November 17, 2016

05311 Version 3

Warranty Extension: 2007–10 MDX and 2010 ZDX Rear Active Damper (6 Months)

Supersedes 16-020, *Warranty Extension: 2007–09 MDX and 2010 ZDX Rear Active Damper (6 Months)*, dated November 8, 2016, to revise the information highlighted in **yellow**

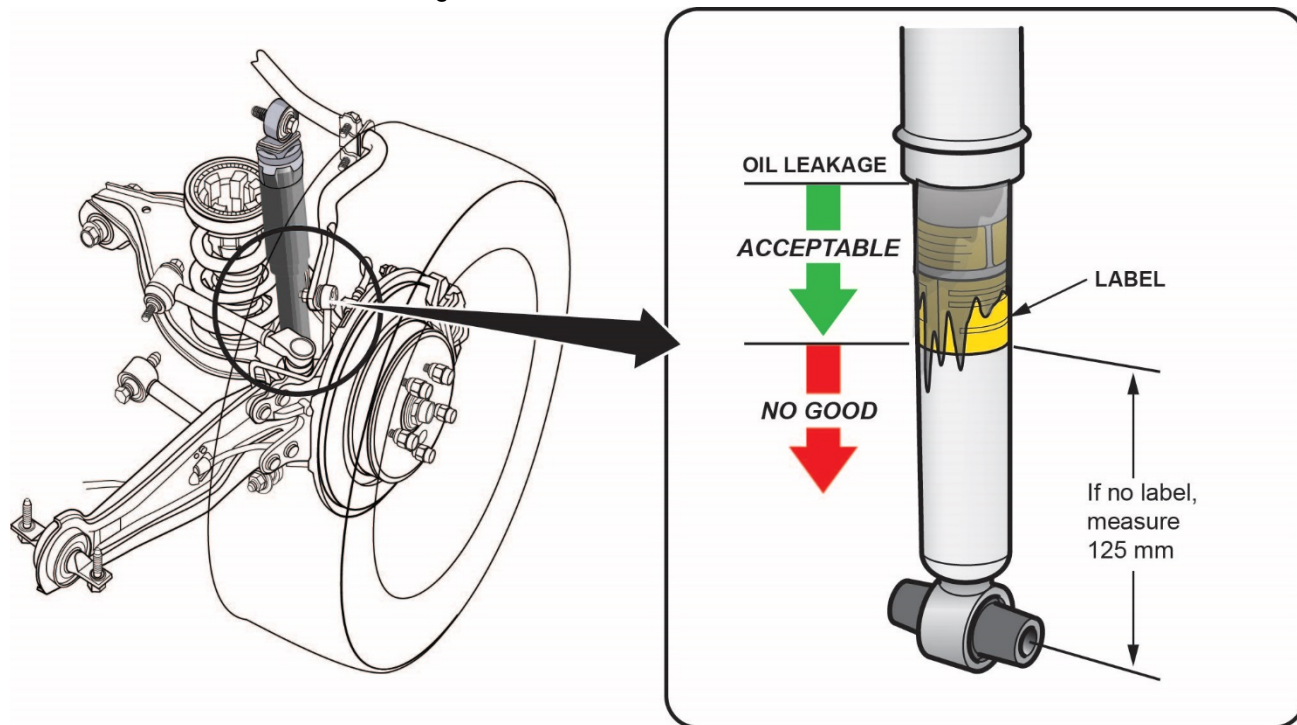
Place the vehicle on a flat surface or raise it on a lift, then inspect the rear dampers for leakage by checking if the oil stains extend below the bottom of the damper label.

NOTE: If the label is damaged or missing, measure a line that is 125 mm above the center of the lower mounting bolt eye.

- **If the oil stains extend below the bottom of the damper label**, go to REPAIR PROCEDURE.
- **If the oil stains do not extend below the bottom of the damper label**, this warranty extension does not apply. Continue with normal troubleshooting.
